DRURY METROPOLITAN CENTRE PRECINCT - CONDITIONS

A: LAND USE CONSENT (s9 [~~consent-ref~~LUC.....])

Figure 1 – Archaeological Sites

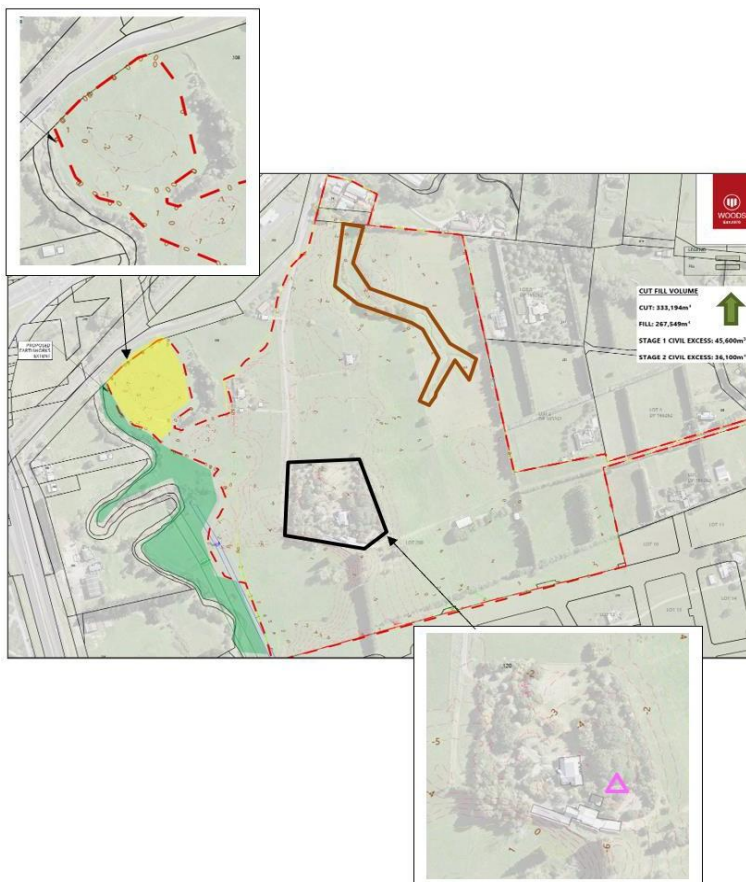
78. The ~~Consent Holder~~~~consent holder~~ must appoint a suitably qualified and experienced archaeologist to supervise preliminary earthworks at the following locations:
- (a) Site R12/1125 (the Flanagan Homestead), outlined in black ~~in the~~ ~~Figure 1~~ below;
 - (b) The 10m riparian margins of Stream A, outlined in brown ~~in the~~ ~~Figure 1~~ below; and
 - (c) The area of archaeological potential relating to the New Zealand Wars, shaded yellow ~~in on the~~ ~~Figure 1~~ below.
